Service Bulletin

No.: MZ08-075

Model: SR5003, SR6003

Subject: INPUT PWB changed to delete soldered wires on the PWB. (The PWB changed for the improvement of product quality.)

Changed

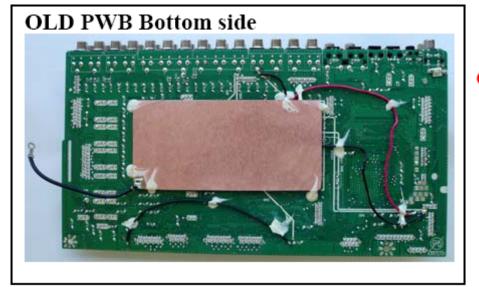
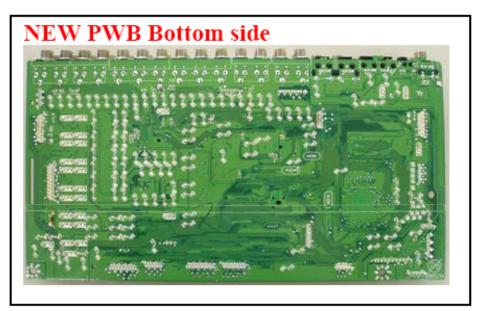
Solution: 1. INPUT PWB: the layout and pattern changed.

- 2. INPUT PWB POS.NO. CN83: Changed into a connector from a connector with CORD.
- 3. Connection Wire: CN83 (FRONT PWB) and BN83 (INPUT PWB) was changed.
- 4. FRONT PWB POS.NO. CN83 (BN83): Changed into a connector with CORD from a connector.
